**TO:** Cassie Younger, Maverik, Inc.  
**FROM:** Stacey Nerger, Senior Planner  
**DATE:** September 28, 2022  
**SUBJECT:** SP21-133 Lincoln Professional Park Filing No. 1 Lot 1 Site Plan

# LINCOLN PROFESSIONAL PARK FILING NO. 1 LOT 1 MAVERIK INC. STORE SITE PLAN

## LANDSCAPE PLAN

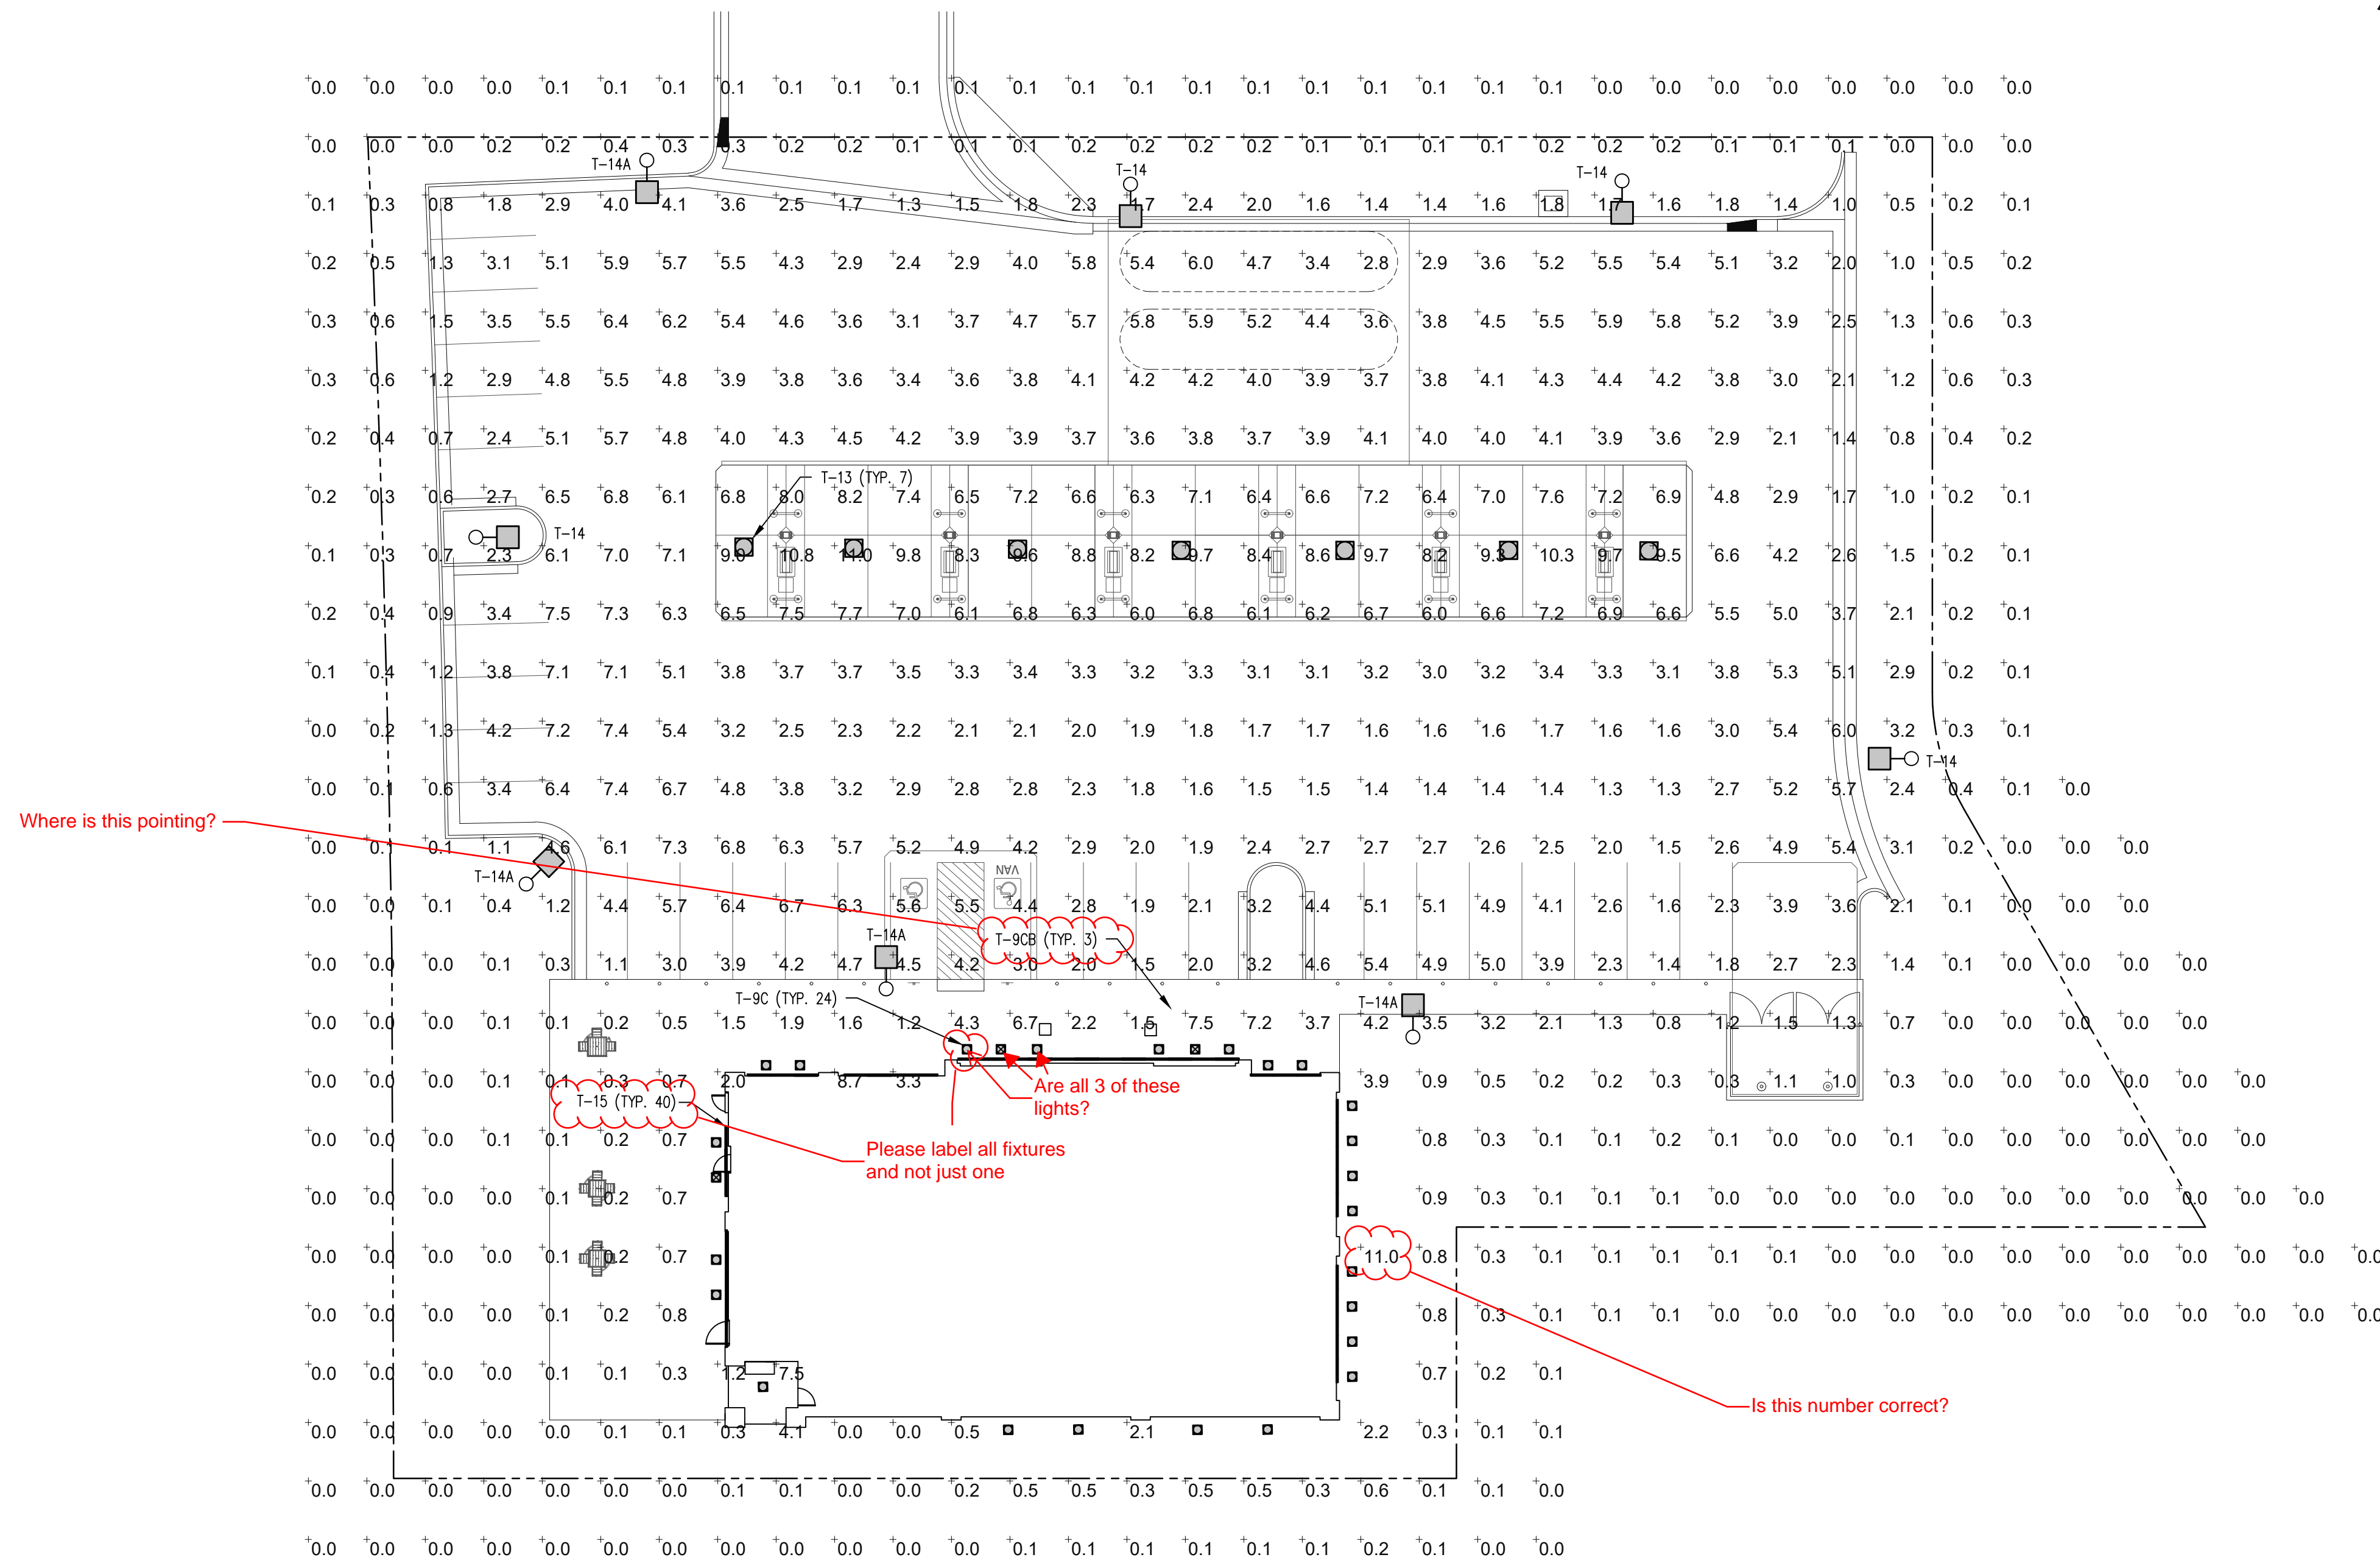
Please note that any area adjacent to the property will need to be landscaped and maintenance will be the responsibility of the property owner. If landscaping between the back of the sidewalk and the property line is not provided as part of the MDP, it will need to be shown on this Site Plan. If additional area will need to be landscaped, a continuation of what is proposed would be recommended.

I don't believe that any landscaping can fit within this area based on page 4. Island is 5 feet in width with a 4 foot sidewalk.

Please ensure the south property line is still satisfied if the shrubs from the island are removed.
